EPC STORMWATER REVIEW COMMENTS
IN ORANGE BOXES WITH BLACK TEXT

~~Master Development Drainage Plan and
Final Drainage Report~~

Peerless Farms
16975 Falcon Hwy
Peyton, CO 80831

PCD File No. SF242

EXISTING DRAINAGE MAP
PEERLESS FARMS
06/24/2024

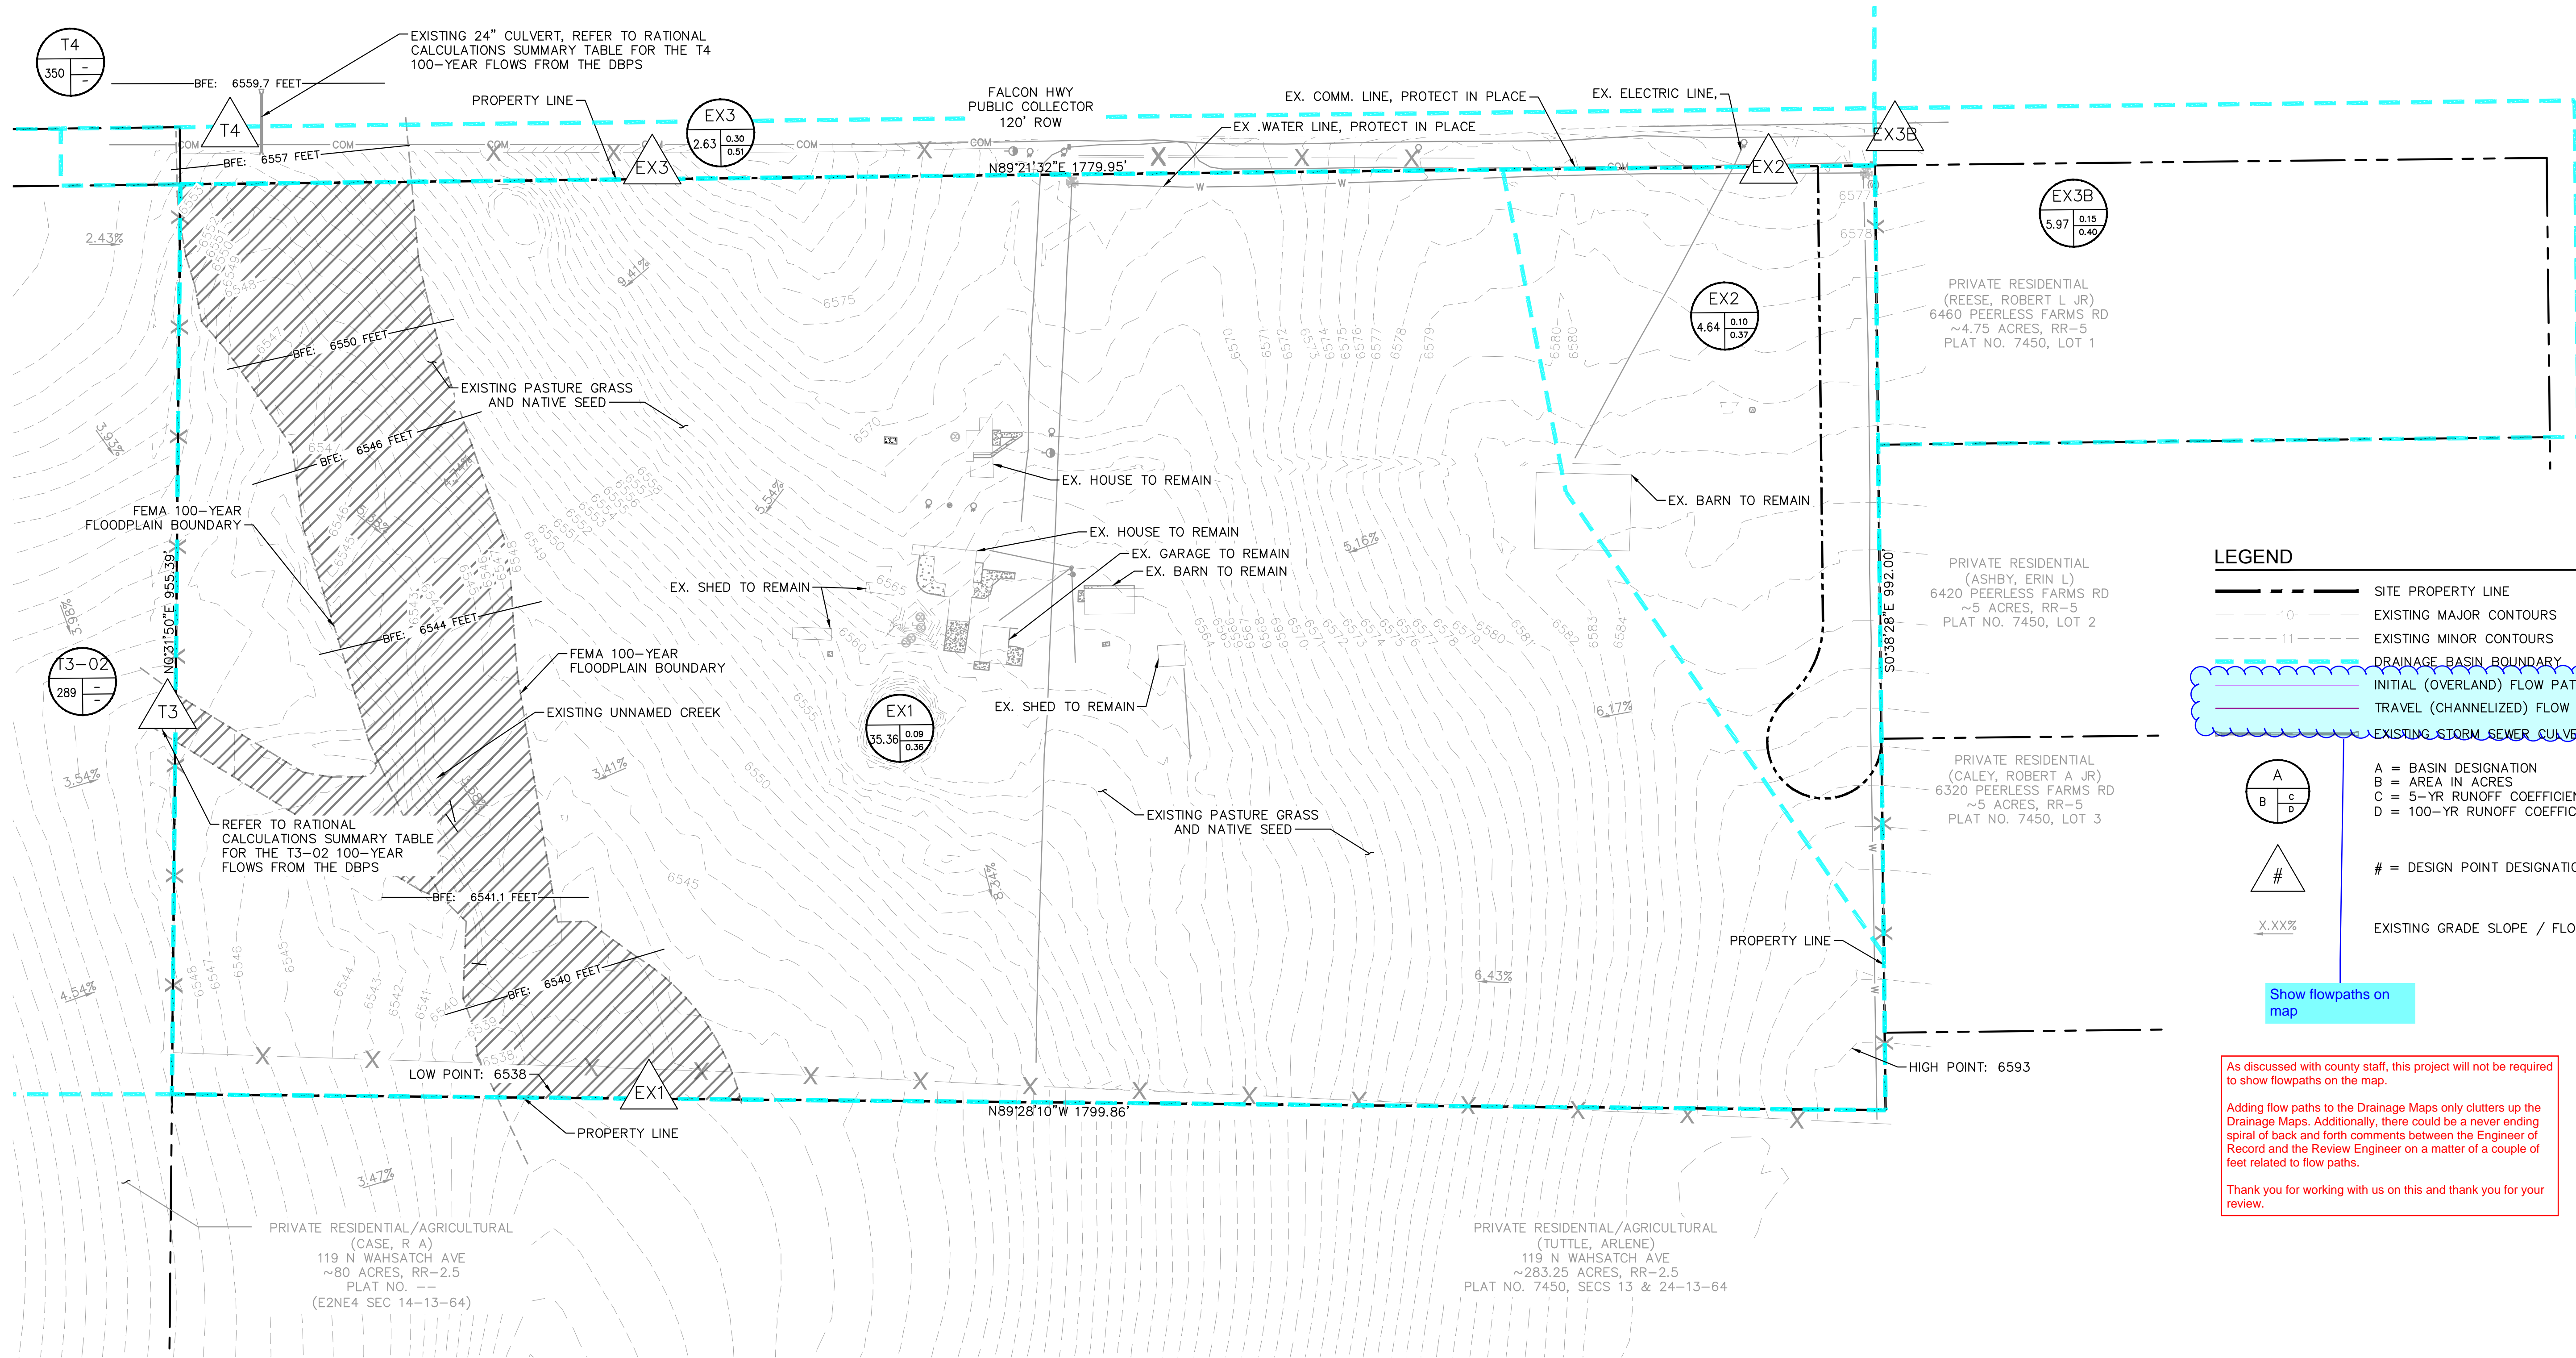
Show flowpaths on map

As discussed with county staff, this project will not be required to show flowpaths on the map.

Adding flow paths to the Drainage Maps only clutters up the Drainage Maps. Additionally, there could be a never ending spiral of back and forth comments between the Engineer of Record and the Review Engineer on a matter of a couple of feet related to flow paths.
